Request for Proposal (RFP)

Addendum No. 5

Project Name: N12(19-4)1,2&4

Owner: Navajo Division of Transportation

**BRIDGE N504 REPLACEMENT
FOUNDATION LAYOUT**

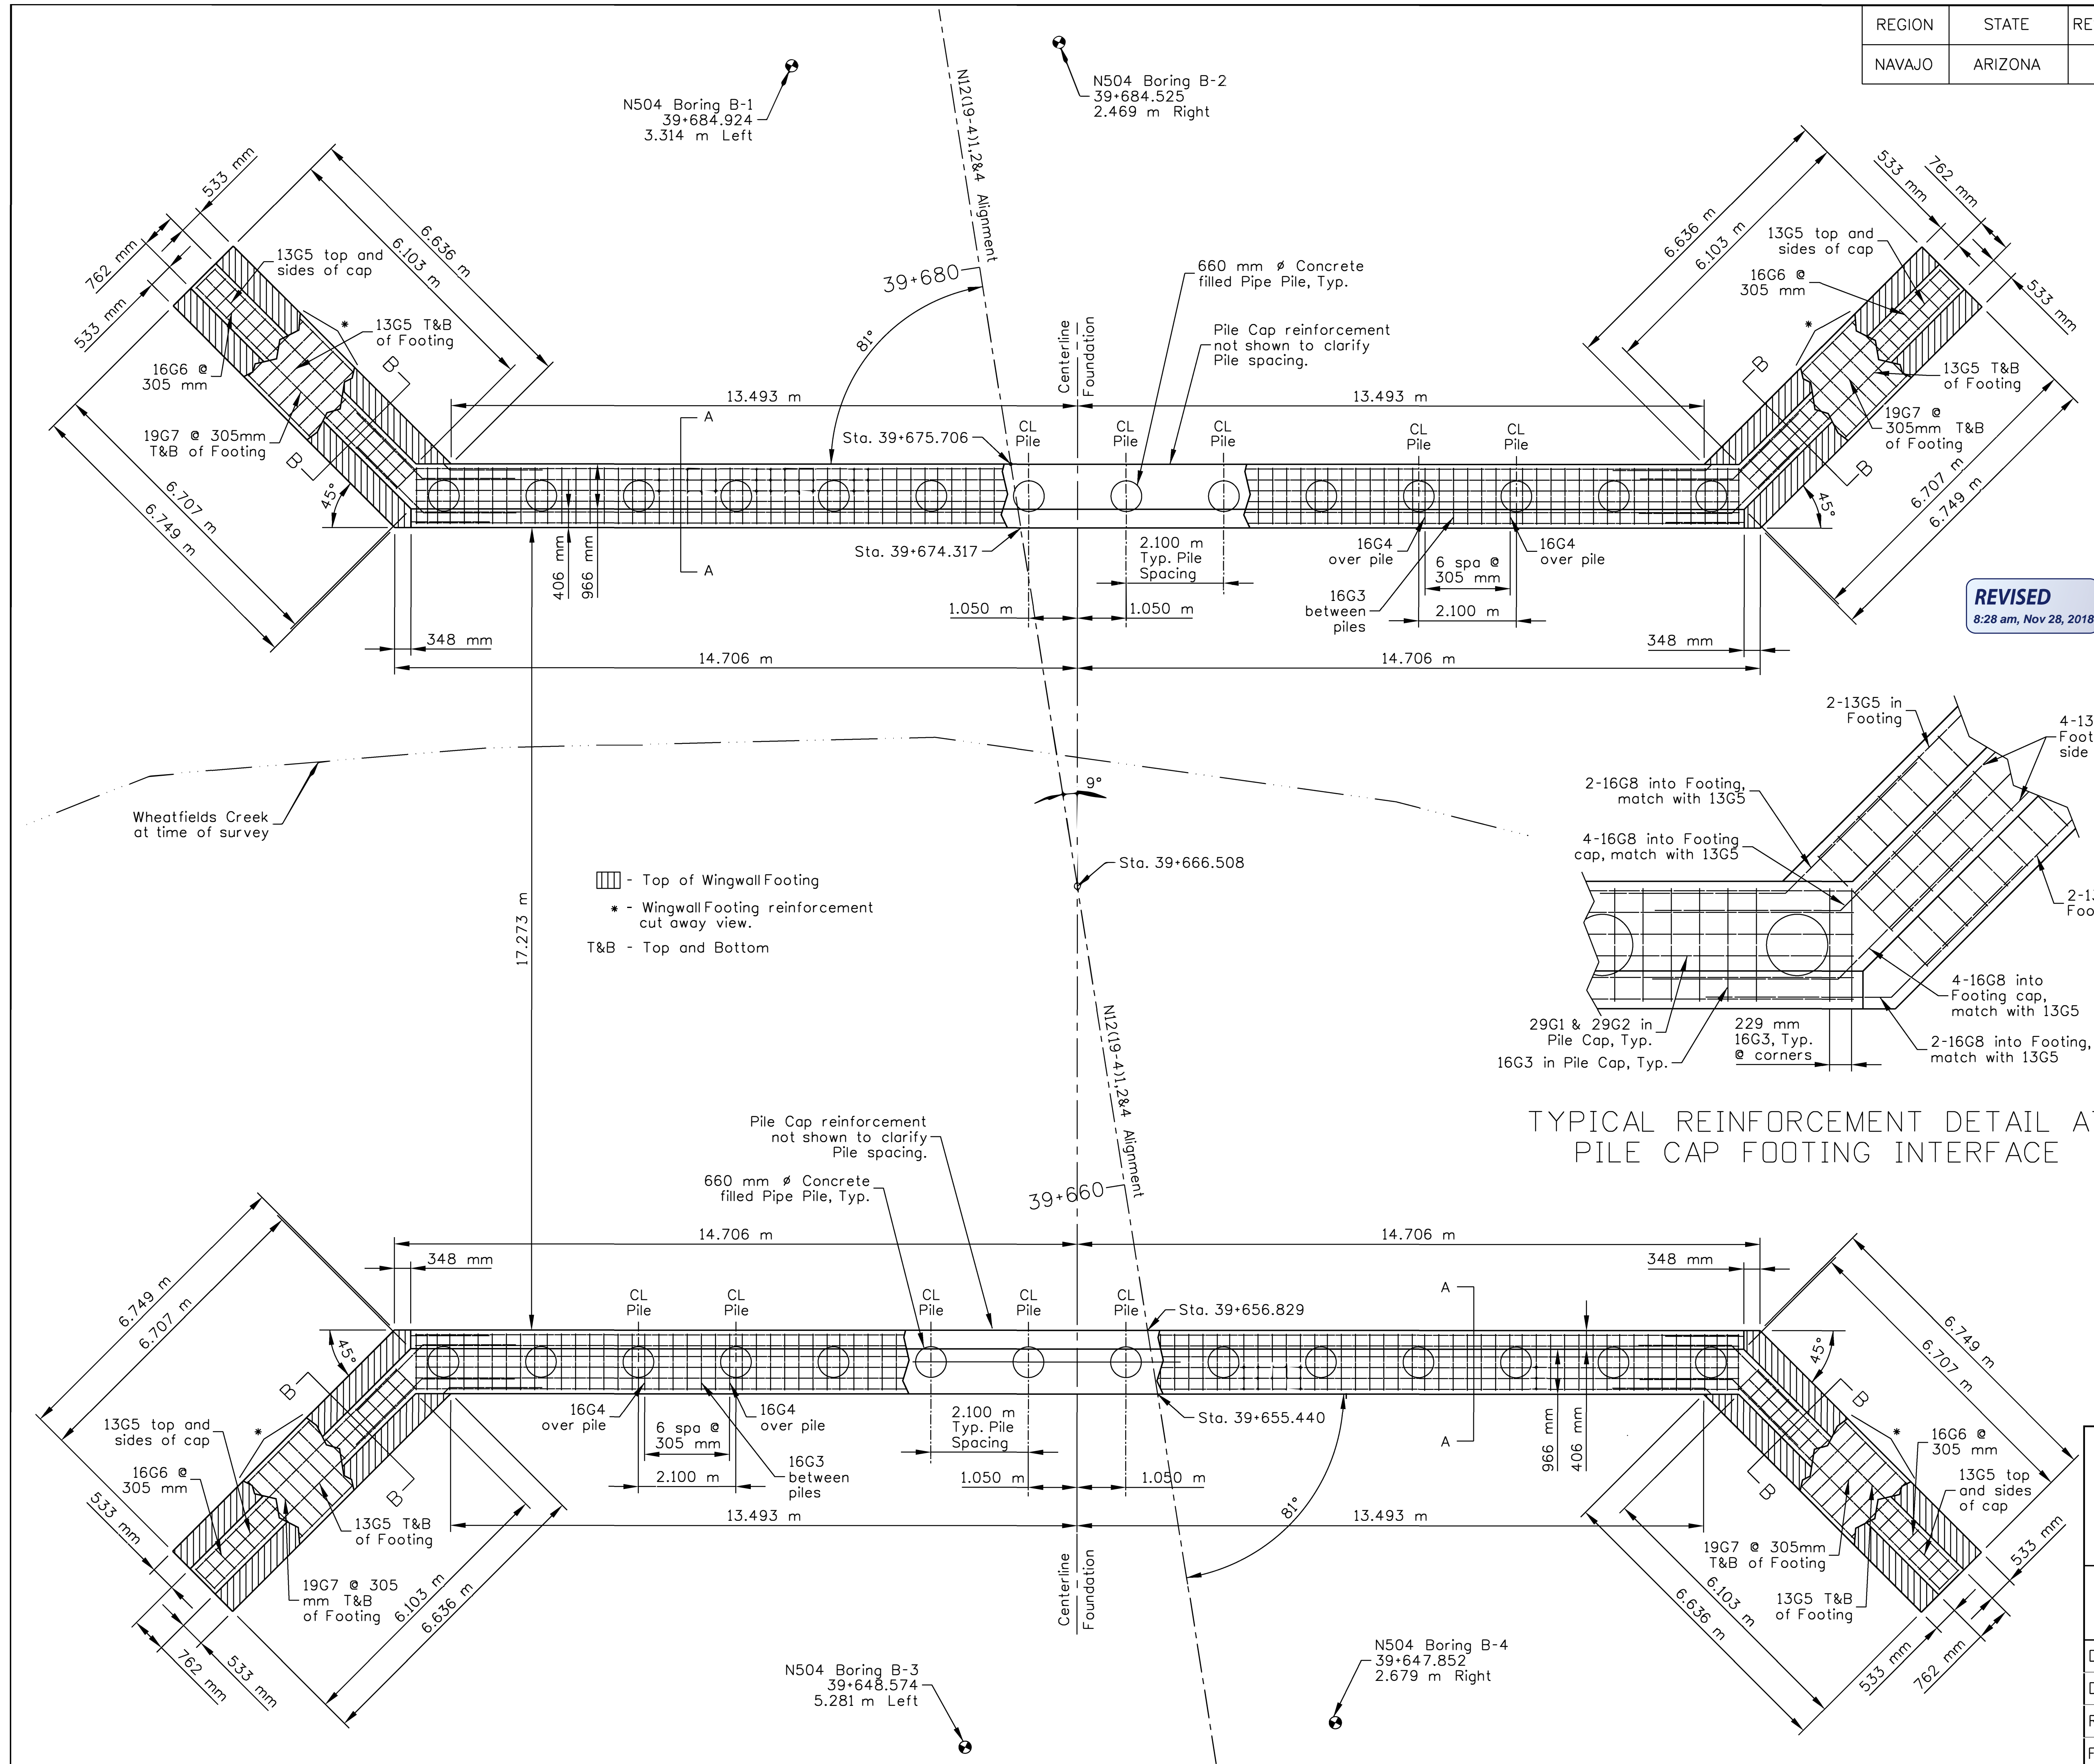
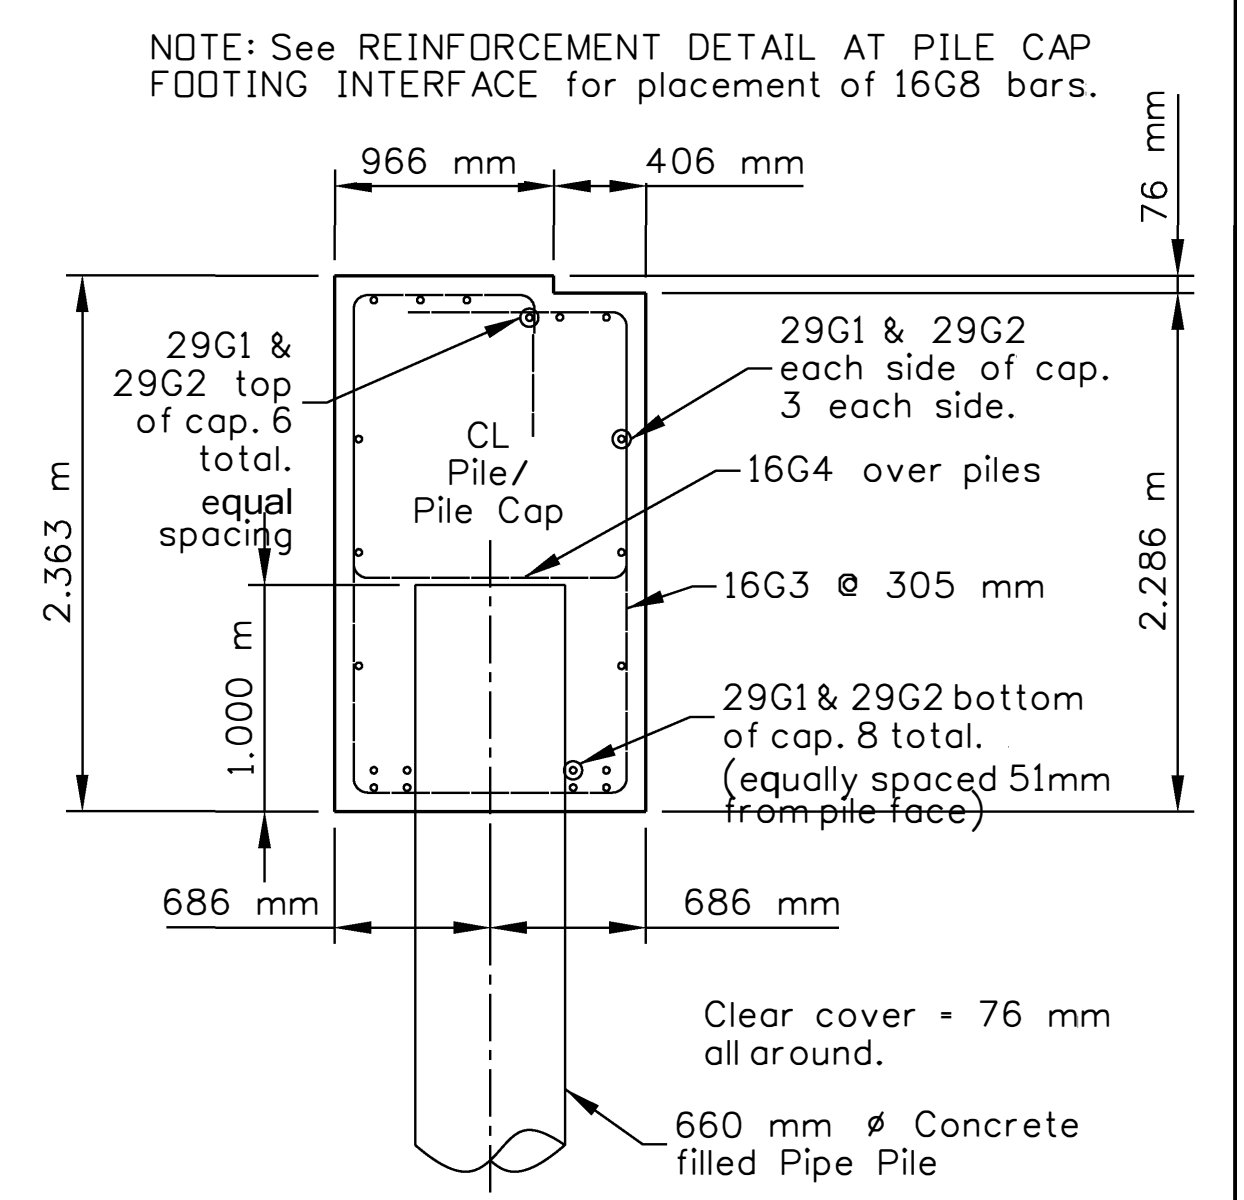
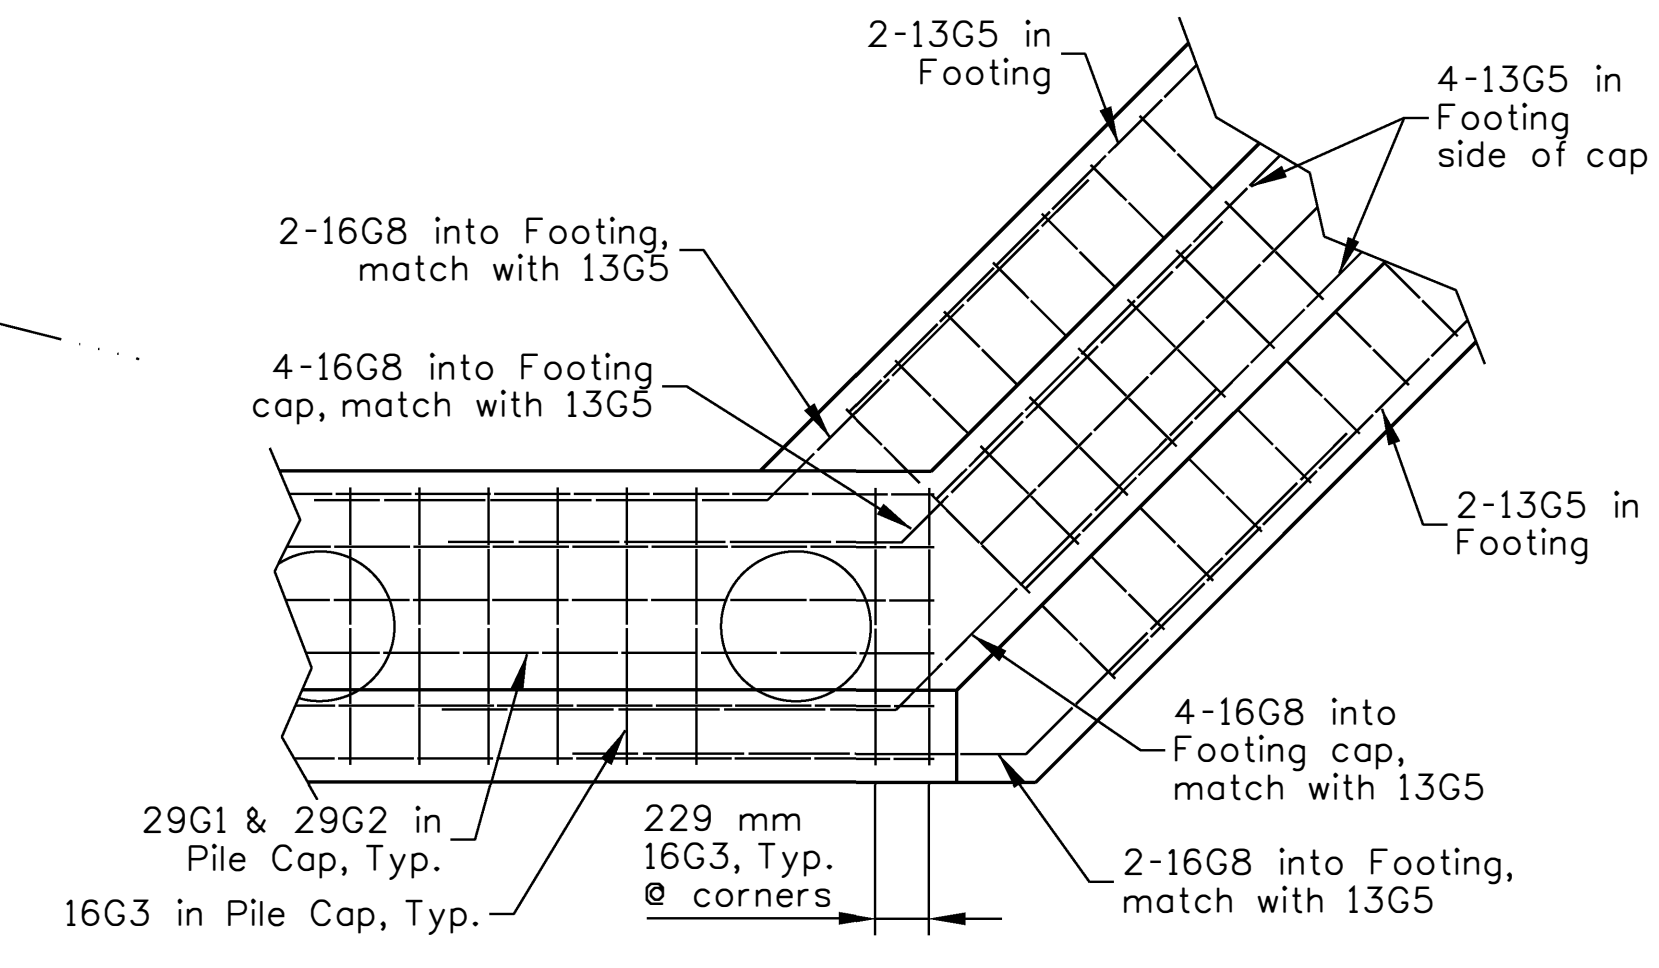
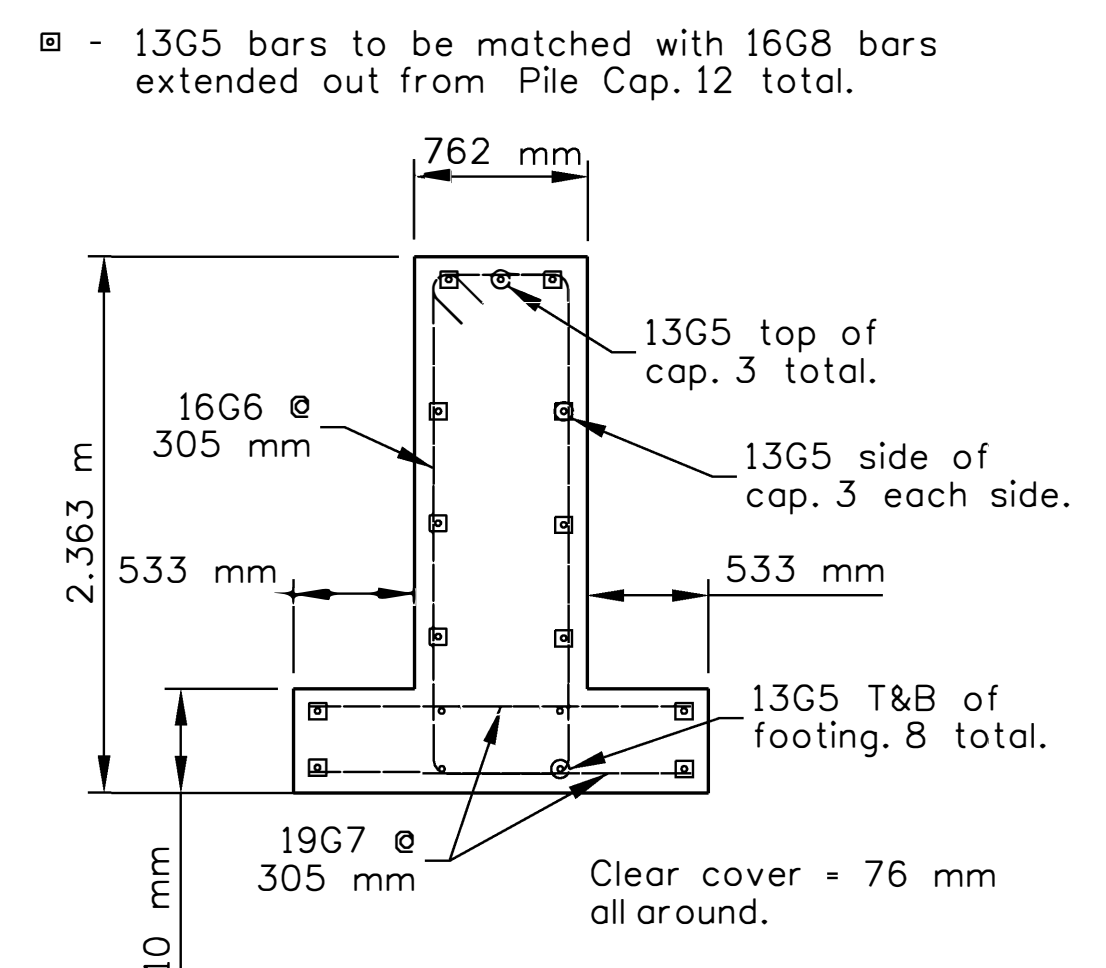
1. The BIA (Engineer of Record) has reviewed and revised two additional plan sheets (B-4 and B-5) based on the questions answered in Addendum No. 4. Please replace these two sheets in the N12(19-4)1,2&4 plan set. The revised plan sheets are attached to this Addendum No. 5 and the overall plan set PDF file has been updated as well.
